**RE: Sunrise Beach, Lot 400  
1222 Severnview Drive, Crownsville, MD 21032**

**ADMINISTRATIVE SITE PLAN**

**SUNRISE BEACH  
LOT 400, SECTION 2, PLAT 1  
1222 SEVERNVIEW DR. CROWNSVILLE, MD. 21032**  
TAX MAP 31 BLOCK 9 PARCEL 144 TAX ACCOUNT #2748-0883-2700 ZONING: R2  
DATE: SEPTEMBER 7, 2023  
SECOND ASSESSMENT DISTRICT ANNE ARUNDEL COUNTY, MARYLAND

## CONFIRMATION OF PRE-FILE MEETING

**PROPOSED  
DEVELOPMENT CONCEPT PLAN  
SCALE: 1"=20'**

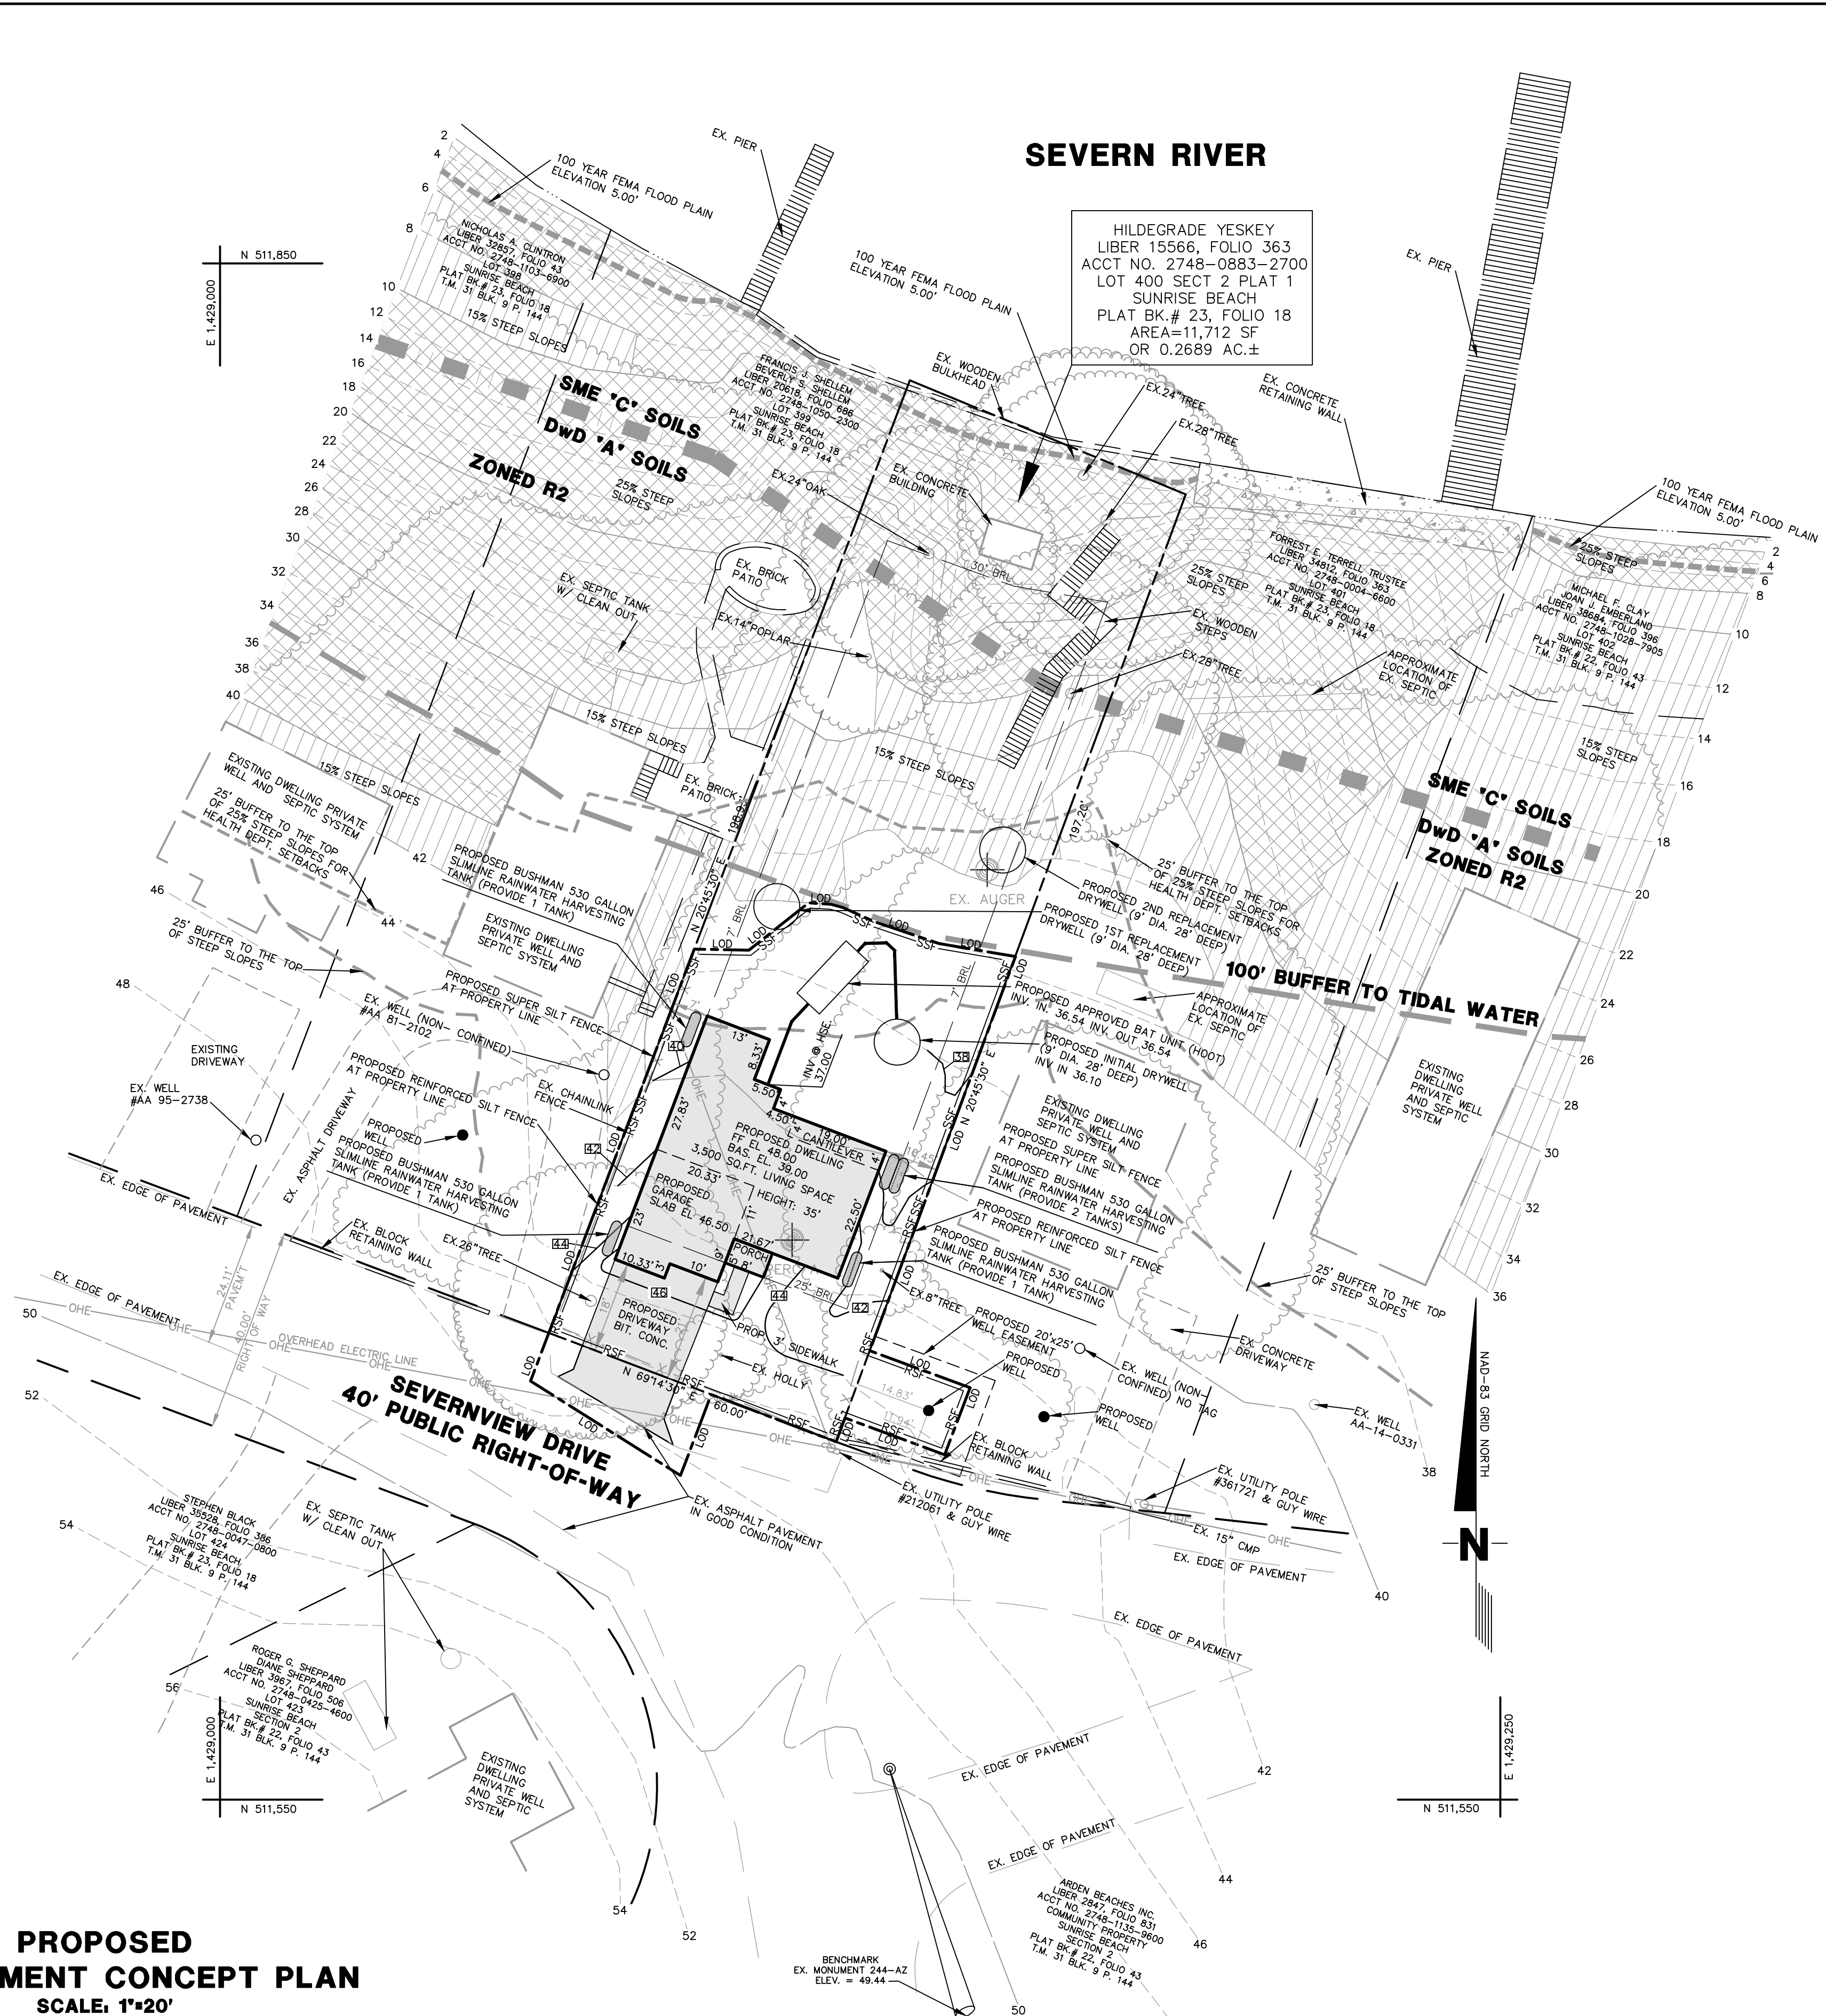
Engineering Division advised that the applicant is proposing to rely solely on rainwater harvesting tanks for SWM. The applicant will need to show sufficient irrigation area and plan of irrigation to validate the suitability of use for these tanks. As shown, this plan does not meet the ESD requirements as it is not demonstrated that the recharge volume is provided.

It is recommended that the applicant explore utilizing permeable pavers or concrete to reduce the imperviousness requiring treatment. Alternatively, the driveway may be cross-sloped to the grass area and disconnected (N-2) that way.

Explore the option of planting and dedicating the back portion of the lot as a natural conservation area. If the MDE criteria are met, this may be considered to satisfy the SWM requirement using non-structural sheet flow to the conservation area (N3). The area must be at least 50 feet wide and 20,000 SF.

Our response: We will provide a plan of irrigation with the grading permit application. We will explore additional SWM options.

Our response: We are not able to use permeable pavement for the driveway because of the required setback to a neighboring water well. The Anne Arundel County Health Department views the permeable pavement as a source of contamination and therefore requires a 50' setback to the well. We will investigate disconnecting the driveway by pitching the slope to the grass area and grading the grass area to a slope less than 5%

Our response: We do not have the required area to use sheetflow to conservation. The area we would be able to put in an easement would be far less than the required 20,000 square feet to be counted as conservation.
